**From:** Comar, Manny  
**Sent:** Thursday, November 01, 2012 5:03 PM  
**To:** TurkeyCOL Resource  
**Subject:** FW: DRAFT RAI Responses FPL Turkey Point 6 & 7 for eRAI 5875 - Surface Faulting  
**Attachments:** Draft Revised Response for NRC RAI Letter No. 043, RAI 02.05.03-4 (eRAI 5875).pdf; Draft Revised Response for NRC RAI Letter No. 043, RAI 02.05.03-3 (eRAI 5875).pdf

**NRC RAI Letter No. PTN-RAI-LTR-043**

**NRC RAI Number: 02.05.03-4 (eRAI 5875)**

**NRC RAI Number: 02.05.03-3 (eRAI 5875)**

Figure 1. Map of McGregor Isles Area

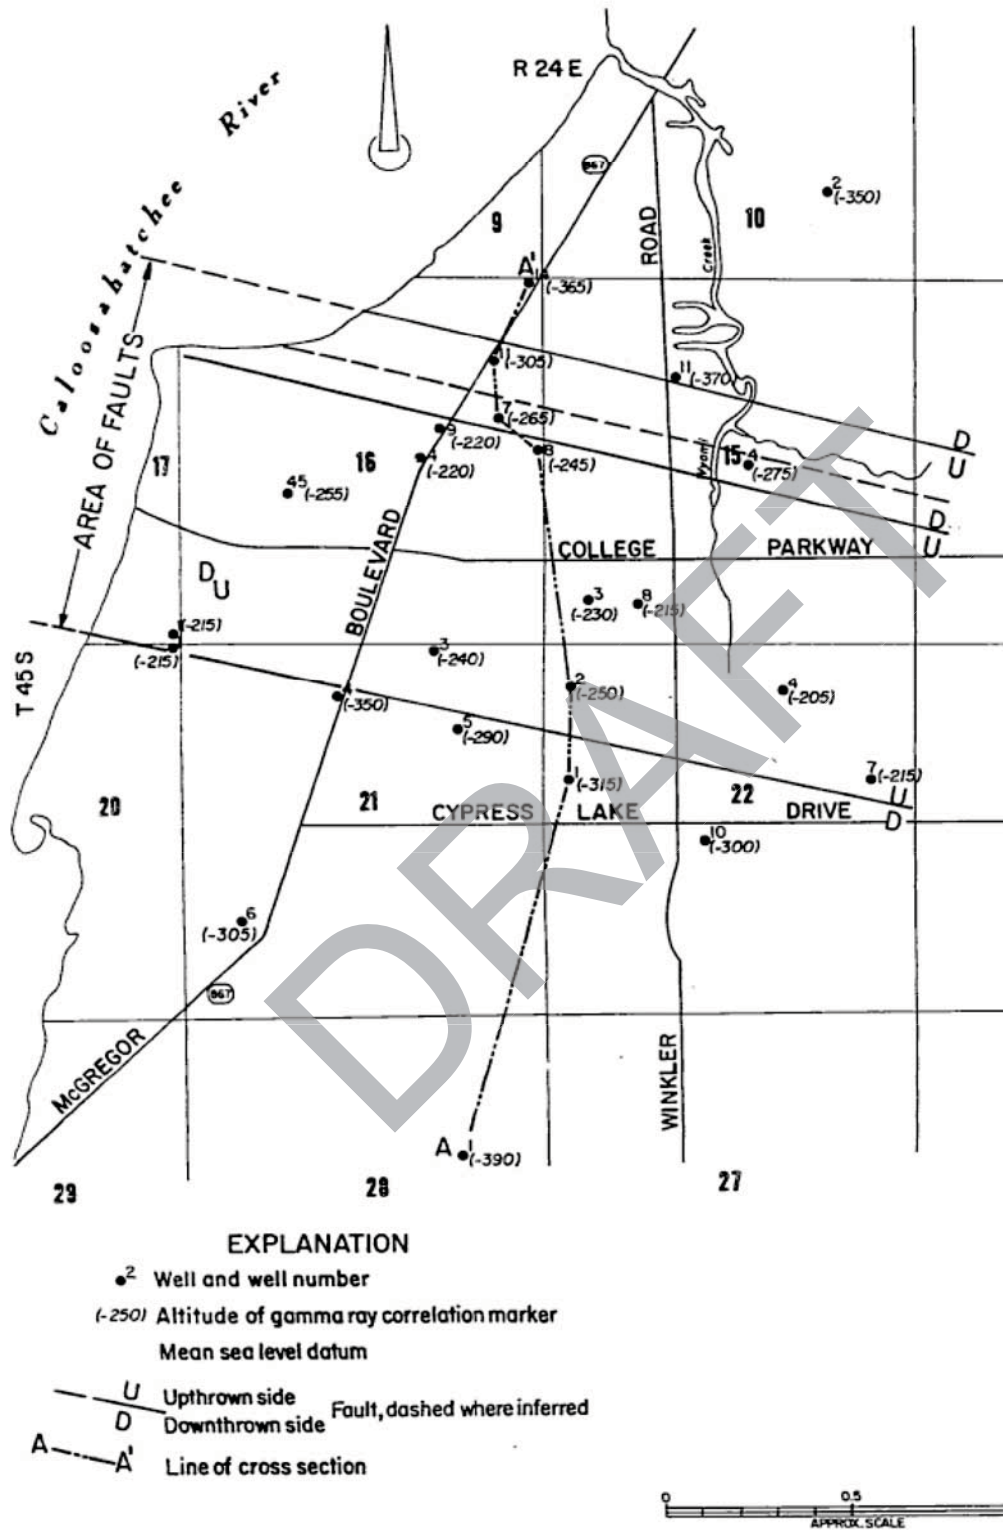
In order for the staff to understand evidence for or against tectonic deformation in Florida Platform specific geology and in support of 10 CFR 100.23, please clarify the apparent inconsistent conclusions that Sproul et al (Reference 230) drew regarding these possible faults. Describe the geomorphic features that Sproul et al referred to and provide more details of your field reconnaissance examination of this area completed for this application.

Sproul et al. (1972) (FSAR 2.5.3 Reference 230) suggest that the “configuration of the Caloosahatchee River shoreline in the vicinity of the northeast corner of section 17 (in Figure 1), and the alignment of a tributary to Whiskey Creek near the center of section 15 are suggestive of fault controlled features” (p. 12 of FSAR 2.5.3 Reference 230) (see Figure 1). The shoreline throughout the northwest corner of section 16 and the southwest corner of section 17 is not aligned with the faults, but a bend in the shoreline does occur near the northern group of 3 faults (see Figure 1). However, the fault located at the apex of the bend is dashed and listed as “inferred”. If the shoreline bend had resulted from Quaternary faulting, the geometry of the bend would indicate apparent dextral slip, not dip-slip as interpreted based on stratigraphic displacement of the marker bed. Surficial strata in this area are mapped as unfaulted Tertiary-Quaternary shell units (Reference 1).

Although the short tributary to Whiskey Creek is subparallel to the proposed faults, the orientation of the main creek drainage in section 15 is at high angles to the trace of the mapped faults, with no apparent offset or deflection along the proposed structures (See Figure 1). A comprehensive geologic mapping effort in Lee County and the Caloosahatchee Basin utilizing well cuttings, cores, quarry pits and the limited natural outcrops does not indicate any surficial faulting in the area (e.g., Reference 1).

**Figure 1. Illustration from USACE Lineament Study and Barnett (1975) Strike-slip Fault**

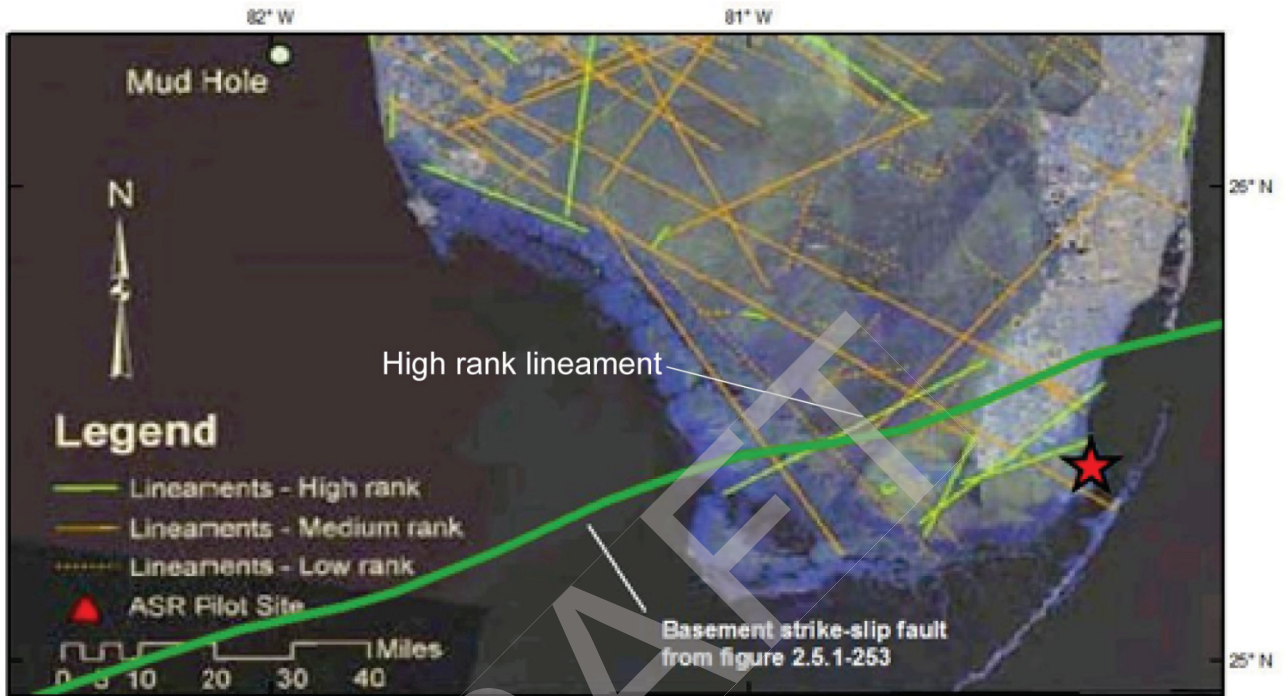
FSAR Section 2.5.3.2, “Geological Evidence, or Absence of Evidence, for Surface Deformation”, states that published geologic mapping at a range of scales show no bedrock faults mapped within the site vicinity (References 211, 213, 224, and 226). However, the staff note, that Figure 2.5.1-253 depicts a strike-slip fault within 25 miles of the site; this feature is also shown as a high-rank lineament on Figure 2.5.3-204.

In order for the staff to completely understand the geologic setting of the site and in support of 10 CFR 100.23 please discuss the high-rank lineament shown on Figure 2.5.3-204, and clarify it’s relationship with the strike-slip fault north of TPNPP shown on Figure 2.5.1-253. Include a discussion regarding how these figures are in agreement with the FSAR Section 2.5.3.2 statement that no faults have been mapped in the site vicinity. Finally, please clarify this apparent disagreement between the text and figures in the appropriate FSAR section(s).

There is no clear relationship between the postulated buried strike-slip basement fault depicted in Figure 2.5.1-253 and the high-rank lineament on Figure 2.5.3-204. As shown in Figure 1, the two features are both northeast-striking, but have different geometries, extents, and locations. No geologic evidence of faulting is reported to support a tectonic origin for the lineaments identified in the USACE study, and no evidence was provided to relate the postulated basement faults at depth to any lineament at the surface (FSAR 2.5.3 Reference 232). The original study by Barnett (1975) (FSAR 2.5.1 Reference 458) did not interpret geomorphic expression of any of the postulated basement faults depicted in Figure 2.5.1-253. FPL interprets the similarity in general location (southern Florida) and strike (northeast) of the high-rank lineament and postulated basement fault to be coincidental.
